Interactive comment on “Predicting tile drainage discharge using machine learning algorithms” by Saghar Khodadad Motarjemi et al.

Saghar Khodadad Motarjemi et al.

Received and published: 21 February 2020

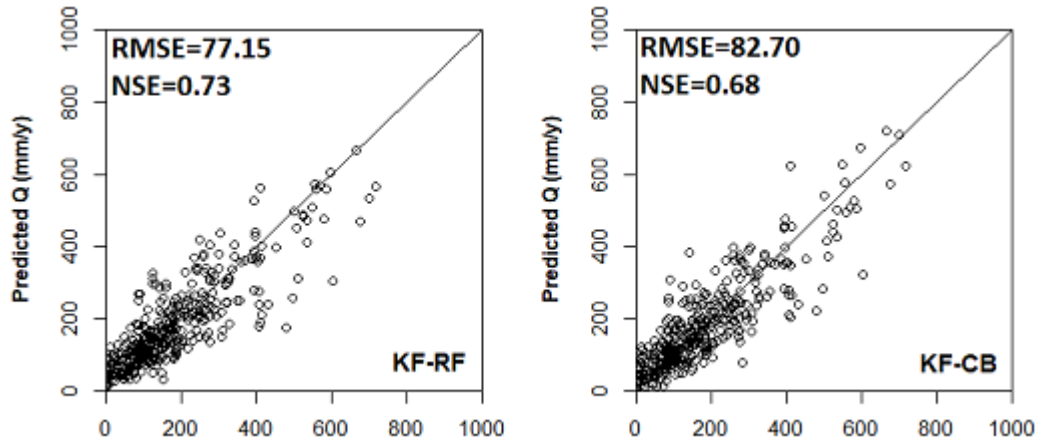
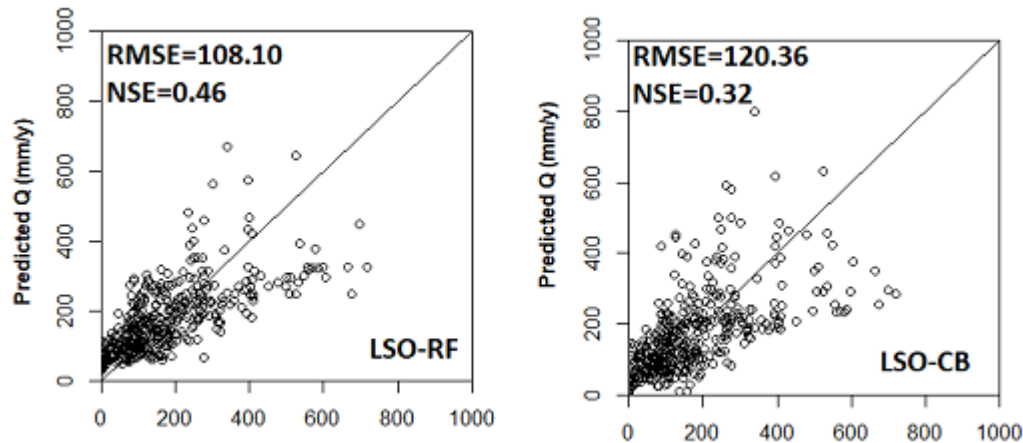
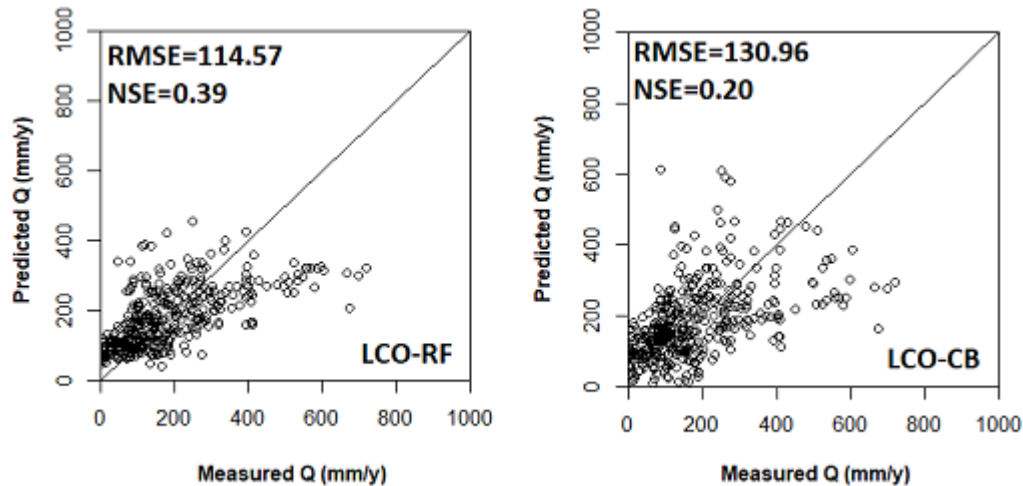
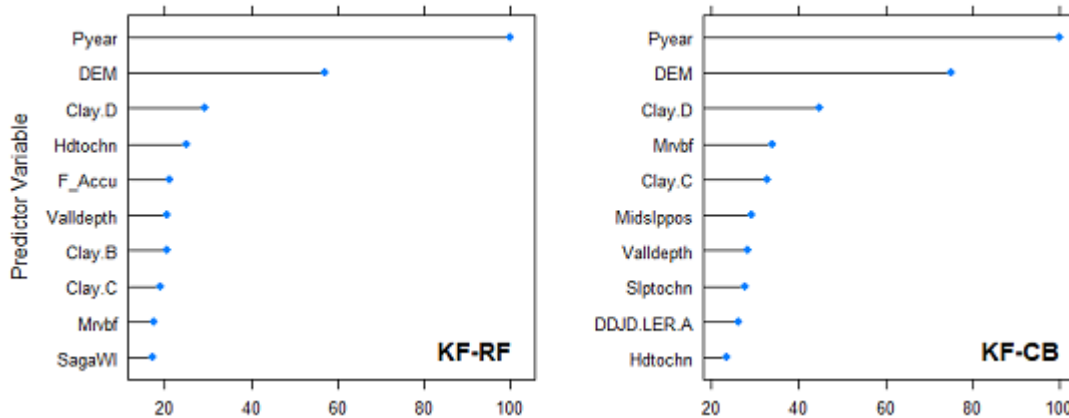
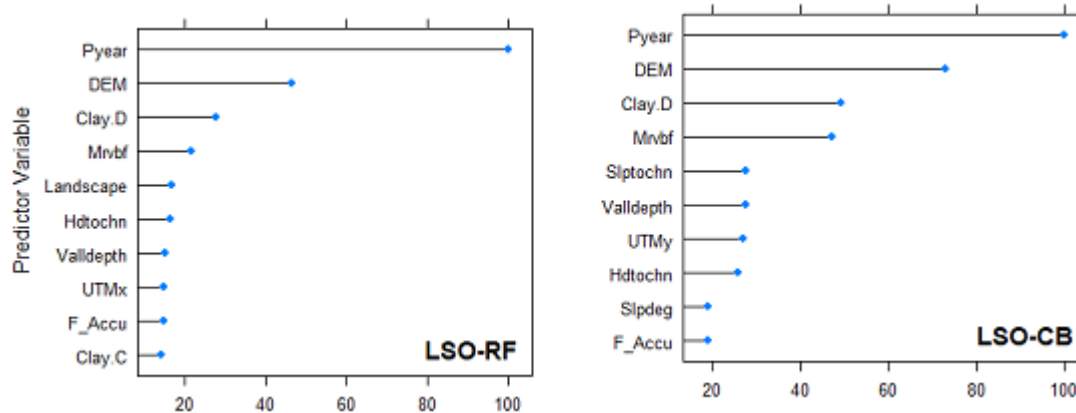
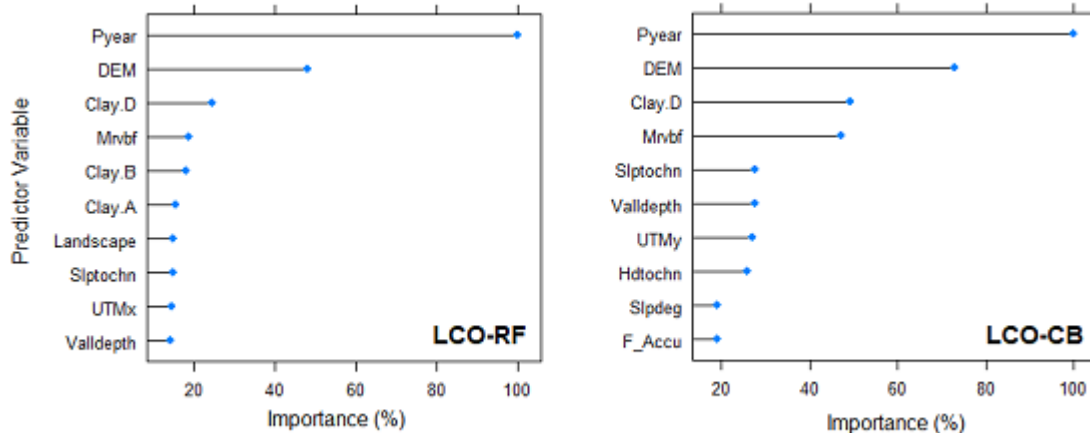
3: Referee comment: To this end, I would rather say that finding out that percolation (Db) is most important attribute upon running huge machinery is not an added value, as that fact is proven by theory and more specific by correlation of both variables discharge and percolation, which is obvious from Figure 7. Rather more interesting contribution would be to see which of precipitation and/or evapotranspiration is more significant in combination with different/specific landscape and soil characteristics. Similarly, second most importantly identified covariate - elevation - is pretty difficult to be simply explained as cause for discharge. The small range of values with pretty small sample size cause a behaviour as a clustering bias, especially if experimental sites are uniformly (equidistantly) distributed along the given range. So instead of discovering more interesting patterns, those are replaced with single covariate that encapsulate different processes under the hood. Therefore, I would rather see what is happening if this covariate is removed.

Authors' reply: The most important reason for using calculated percolation instead of measured precipitation is the summer precipitation events, which would not affect the drainage discharge. Denmark has a precipitation deficit in the summer, and the root zone therefore stores most of the precipitation during the summer. Precipitation is distributed over the entire year. Large precipitation events occur both during the winter half year as well as during the summer half year. In our study, we aim at predicting the yearly drain discharge due to the low temporal resolution of a large portion of our drainage discharge data set. Using the EVACROP-simulated Db instead of precipitation will eliminate drain discharge during the growing season where large precipitation events seldom will trig any significant tile drain discharge events. However, the model was also ran with the precipitation as a covariate instead of percolation and the results of model accuracies and the most important covariates are presented in Figures 1 and 2, respectively. The accuracy of the models are not significantly different compared to the results reported on the manuscript with Db as covariate. In Figure 7 of the first version of the manuscript, tile drainage discharge shows a U-shaped relationship with elevation. This shows that topography can have an effect on discharge, which Db does not account for. As we used the 1-dimensional EVACROP model to calculate Db, this covariate does not account for topography. The observed pattern is most likely a combination of several effects. Firstly, higher elevations receive more precipitation, which would increase discharge. Secondly, EVACROP does not account for surface flow. Lower elevations are likely to receive additional water from upslope positions, which would increase discharge. Thirdly, lower elevations will often have a shallower depth to the groundwater, and groundwater flow from higher positions may therefore contribute to the increased discharge. Together, these explanations show why intermediate elevations may have less discharge than higher and lower elevations. To assess the effect of excluding DEM, the model was run without the covariate and the results are shown in Figures 3 and 4. The accuracy of the models do not show a noticeable change after excluding the DEM as a covariate. Regarding the most important predictors, horizontal distance to the channel (Hdtochn) and clay content in the D horizon (Clay.D) appear as

the second and third most important variables after precipitation. These two covariates also had high importance in the models that used elevation as a covariate. The results mainly show the adaptive behavior of machine learning models. When an important covariate is missing, the algorithms can to some extent use other correlated covariates to act as proxies. For example, valley depth and vertical distance to channel may act as proxies for elevation. Presented results in this discussion could be also included in the paper to provide a comparison.
